DEPARTMENT OF NATURAL RESOURCES

SUBJECT: Surface Use Lease and Mining and Reclamation Plan for the Eagle Project

Eagle Project

Foth Infrastructure & Environment, LLC				 Kennecott Eagle Minerals	
REVISED	DATE	BY	DESCRIPTION		
				FIGURE 1 PORTAL ABANDONMENT	
CHECKED BY: JOS1		DATE: DEC. '07		Scale: NOT TO SCALE	Date: DECEMBER, 2007
APPROVED BY: SVD1		DATE: DEC. '07		Prepared By: JOW	Project No. 04W018
APPROVED BY:		DATE:

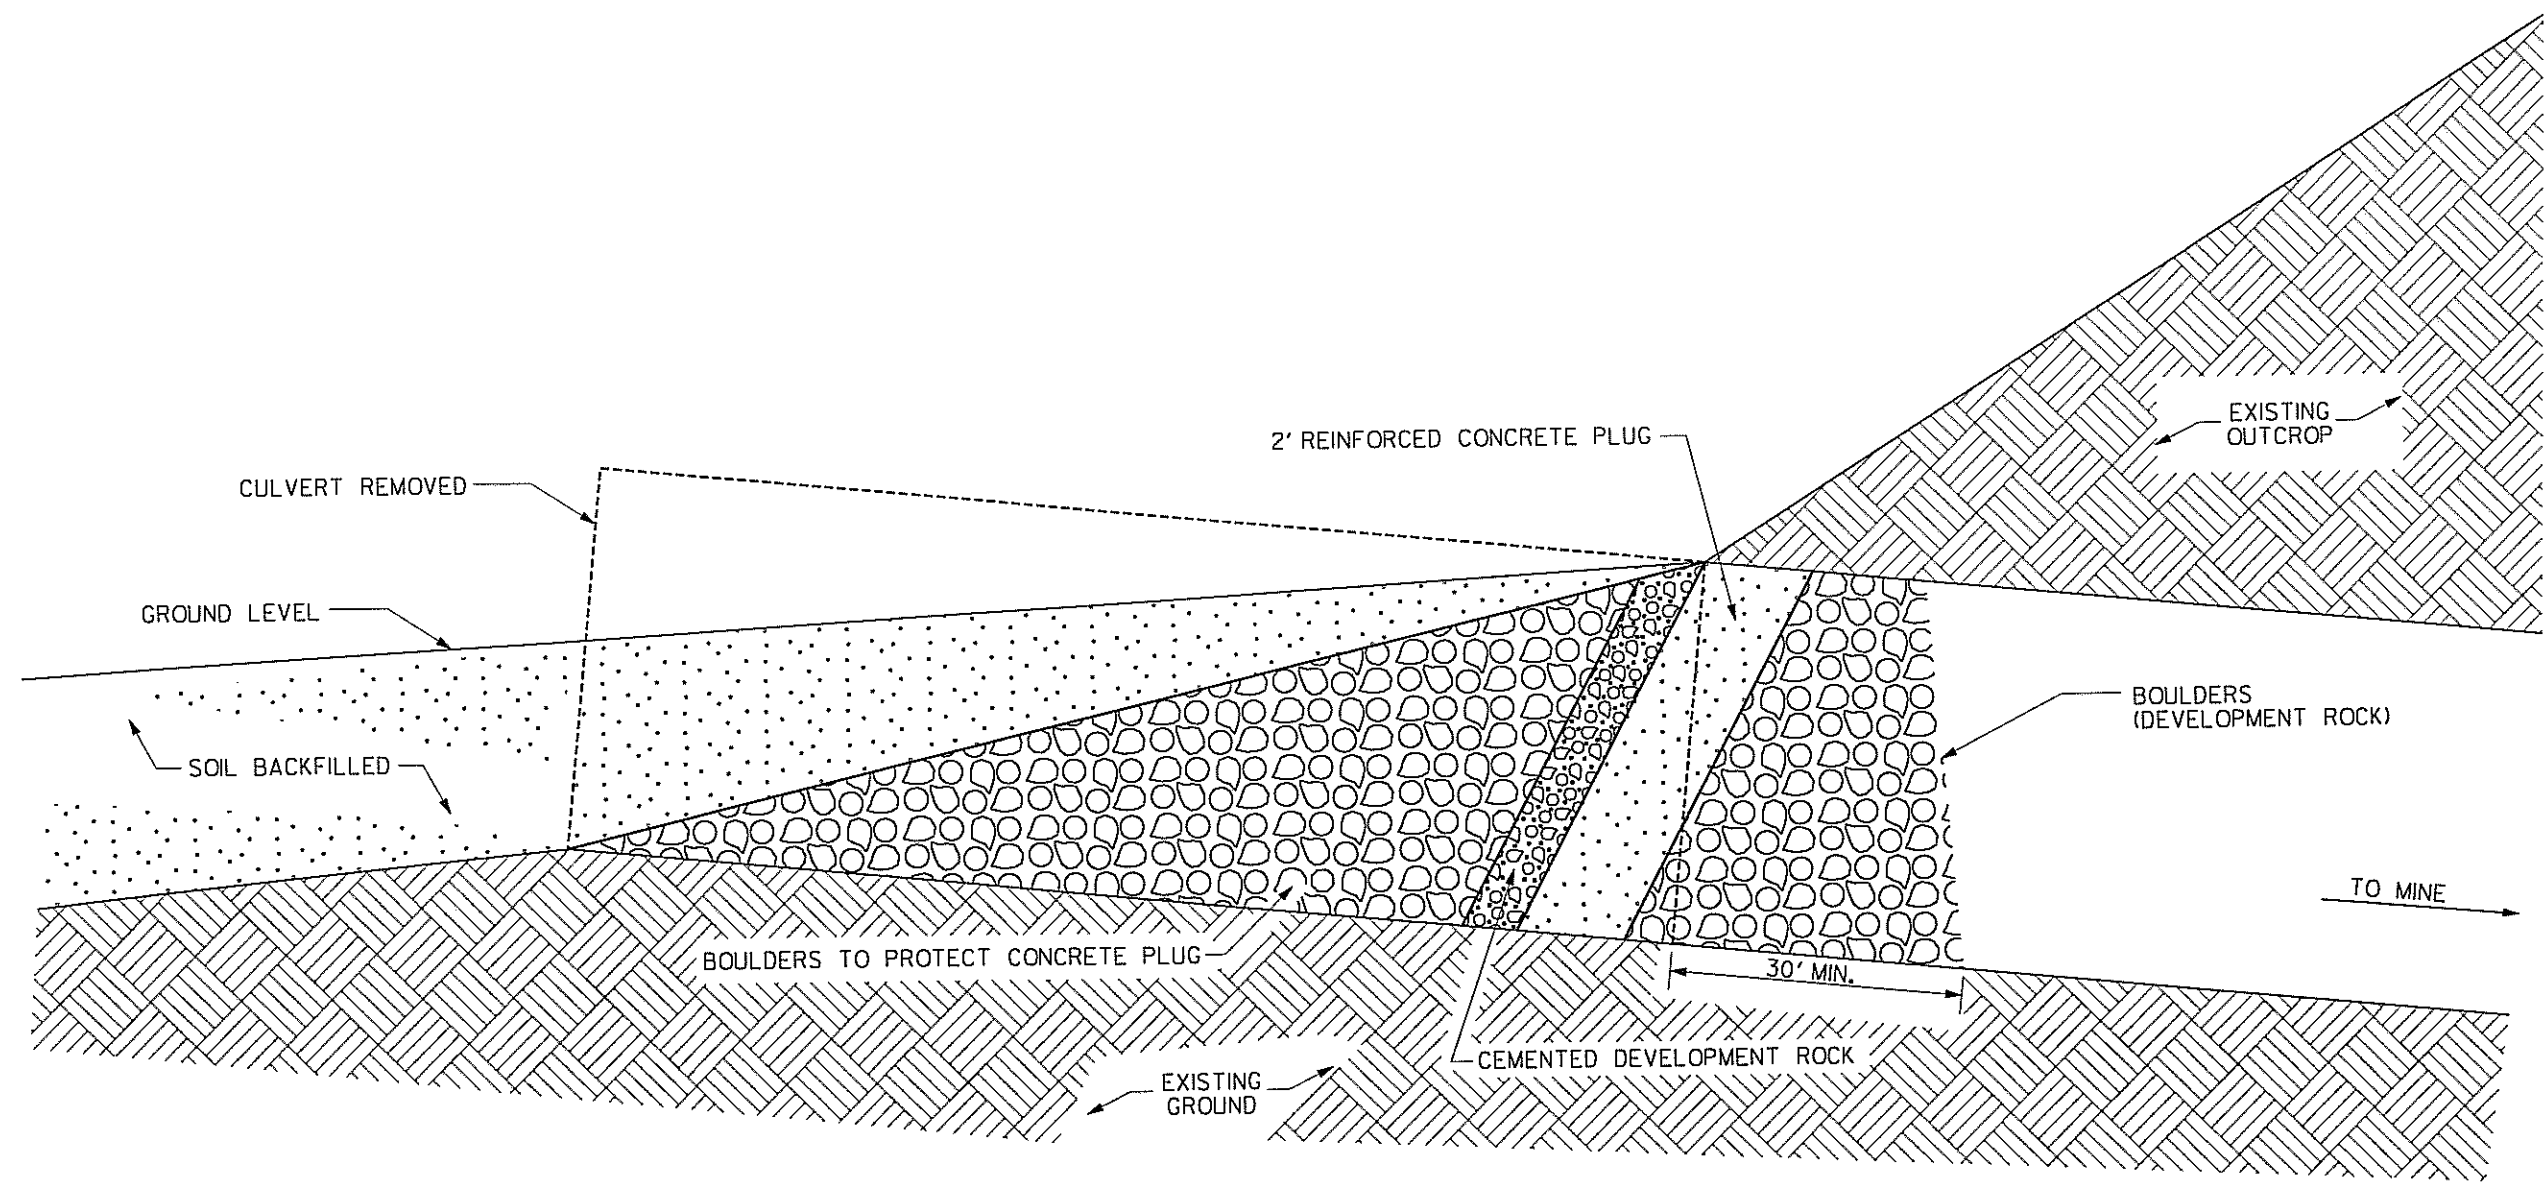
Kennecott provided the Portal Abandonment Plan to prevent access to the portal plug.

The DNR modifies the Mining and Reclamation Plan to incorporate the Portal Abandonment Plan to address abandonment of the portal near the surface.
